HISTORIC AND DESIGN REVIEW COMMISSION

HDRC CASE NO: 2016-358
ADDRESS: 515 MCCULLOUGH AVE
LEGAL DESCRIPTION: NCB 431 BLK 17 LOT 25 FIRST BAPTIST CHURCH
ZONING: FBZ T6-1 HS RIO-2
CITY COUNCIL DIST.: 1
LANDMARK: First Baptist Church / Webb Hall
APPLICANT: Benjie Daniels/Latitude Architects, Inc.
OWNER: First Baptist Church of San Antonio
TYPE OF WORK: Courtyard modifications, covered walkway removal, signage and fencing
REQUEST:

The applicant is requesting a Certificate of Appropriateness for approval to:

15 | baptistery side elevation

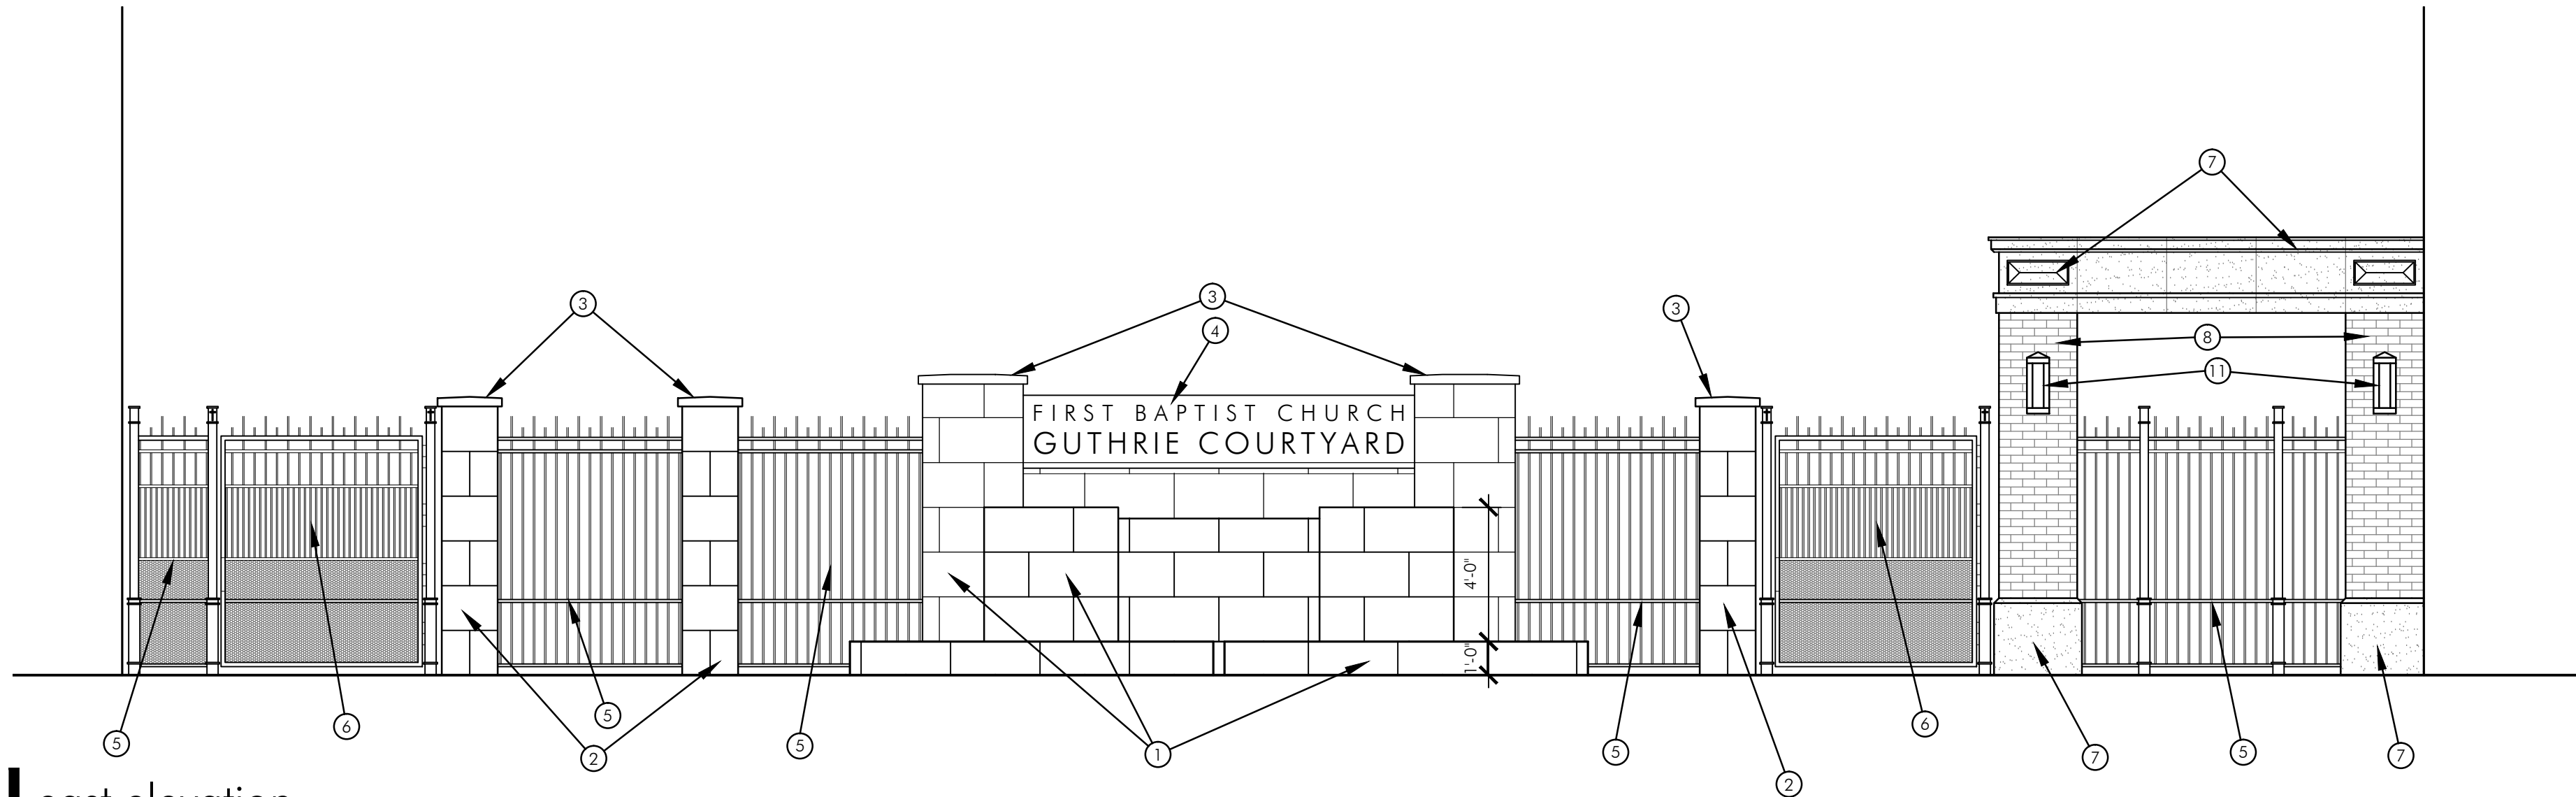
- e. **FENCING** – The applicant has proposed to install a new fence along the public right of way at Fourth Street to enclose the courtyard. The applicant has proposed fencing to consist of limestone veneer, steel fence panels and steel gates. The proposed baptistery’s rear wall will function as a section of the proposed fence. Staff finds that the proposal to install a fence at this location is appropriate; however, staff finds the proposed limestone veneer to be inappropriate and inconsistent with the Guidelines for Site Elements 2.B.i., which states that new fences and walls should respond to the design and materials of the primary structure. Staff finds that brick veneer instead of limestone would be appropriate.

- f. **FENCING** – The applicant has proposed an overall height that varies from approximately 8’ – 0” in height to approximately 8’ – 8” in height. According to the UDC Section 35-674(h) (1), site walls are to be used to divide spaces, create a variety in landscaping and define edges. Additionally, solid walls up to six (6) feet in height are permitted. Staff recommends the applicant reduce the overall height of the proposed fence to no more than six (6) feet in height. Staff finds that the overall height of the baptistery wall is appropriate and its current height given that this structure acts as more than only a wall.

1. That the applicant incorporate brick into the proposed fence and baptistery wall.
2. That the applicant reduce the overall height of the proposed steel fence and columns to no more than six (6) feet in height.
3. That the applicant provide additional information in regards to the proposed sign.
